service bulletin

MERCURY OUTBOARDS

NUMBER: 79-2

- A. Oversize Pistons and Rings - V150 and V175 Models
- B. Salt Water Corrosion - Gear Housing Bearing Carrier and Cover Nut
- C. Wiring Harness Ring Terminal Insulation
- D. Wear Sleeves - Crankshaft Salvage
- E. Starting Procedure - 1976 and Newer Merc 650-700-800-850

**Figure 1. Wear Sleeve
Installed on Crankshaft**

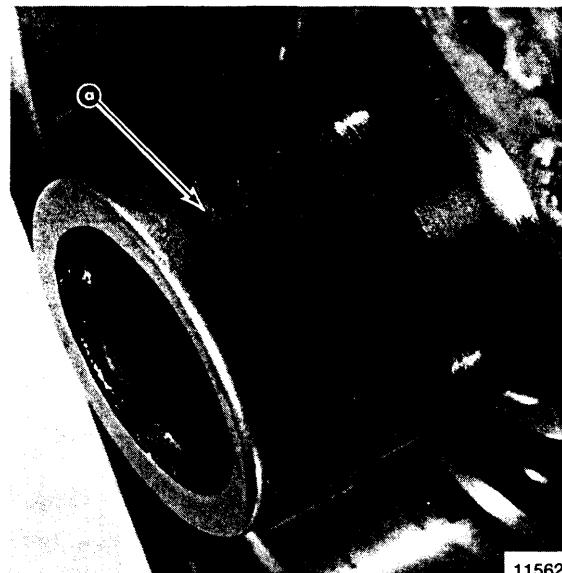
A new wear sleeve -- available to you in part numbers, below -- will salvage crankshafts on **3, 4** and **6**-cylinder models where corrosion has damaged the lower oil seal surface. See Figure 1 for wear sleeve installed.

A-86348A1 Merc 40 thru 70 HP Models

8-86349A1 Merc 80 thru 200 HP Models
